To: Katherine Schultz, Chair,  
Planning and Sustainability Commission

## **Comments on Pedestrian Issues in Mixed Use Zones Proposed Draft, March 2016**

Figure 130-11  
Ground Floor Windows

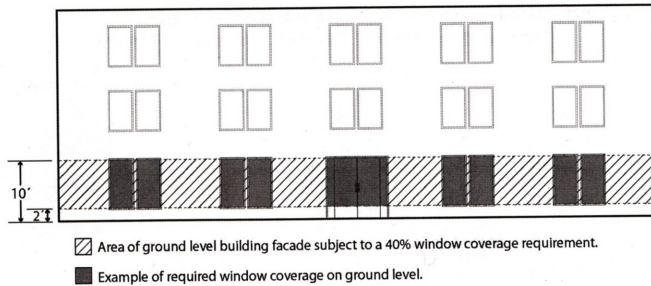
I am concerned, however, that the requirement for a 4' high maximum for the bottom of windows is being removed from 33.130.230, C. The main purpose of the regulation is to allow pedestrians to see into stores, and for those inside to be able to see people on the outside, and see activities in the street and call for help when it is needed, as well as provide an interesting and varied pedestrian experience.

Without this maximum bottom height, there are many places where builders don't want to have windows, and will take advantage of this, resulting in windows with their sills at 6 feet, say, and extending to 10 feet height to achieve the required window area, while leaving pedestrians no connection to the life inside the building.

Staff contends the larger required percentage will often force the windows to reach down to the 4' level anyway. Here's their diagram from the proposal:

Here’s one solution: Add this language to 33.130-230, C.:

“To qualify, a single window must have the bottom no more than 4 feet above the adjacent exterior grade, and the top no less than 6 feet above that grade. Other windows directly above and below this “qualifying” window also qualify, if between the 2’ and 10’ heights. Horizontal dividers (muntins) less than 2 inches high are allowed within any window.”

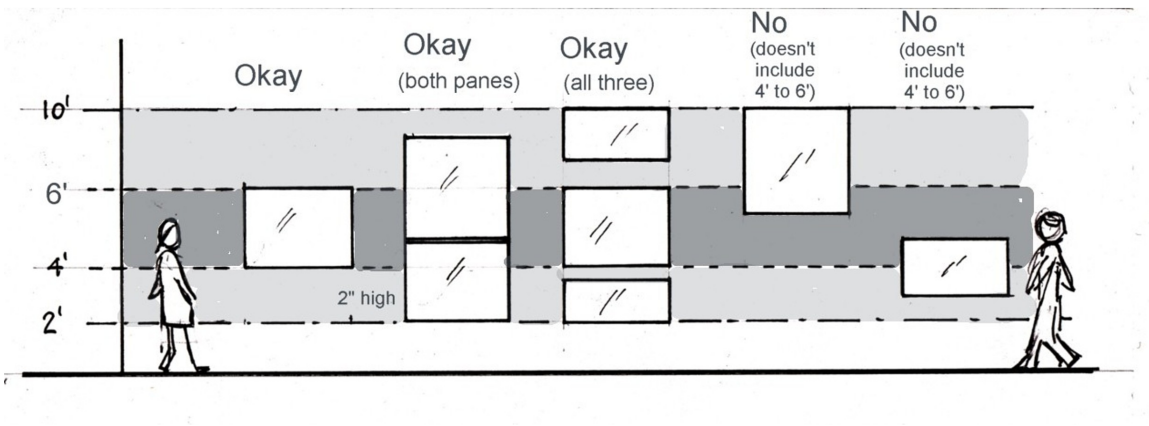
Yet it doesn't take much imagination to see how a builder can use windows with their bottom at 6' above grade to satisfy the same requirement:

This example window, with a bottom at 6.5 feet and top at 8 feet, would count as a "Ground Floor Window" under the proposed regulation:
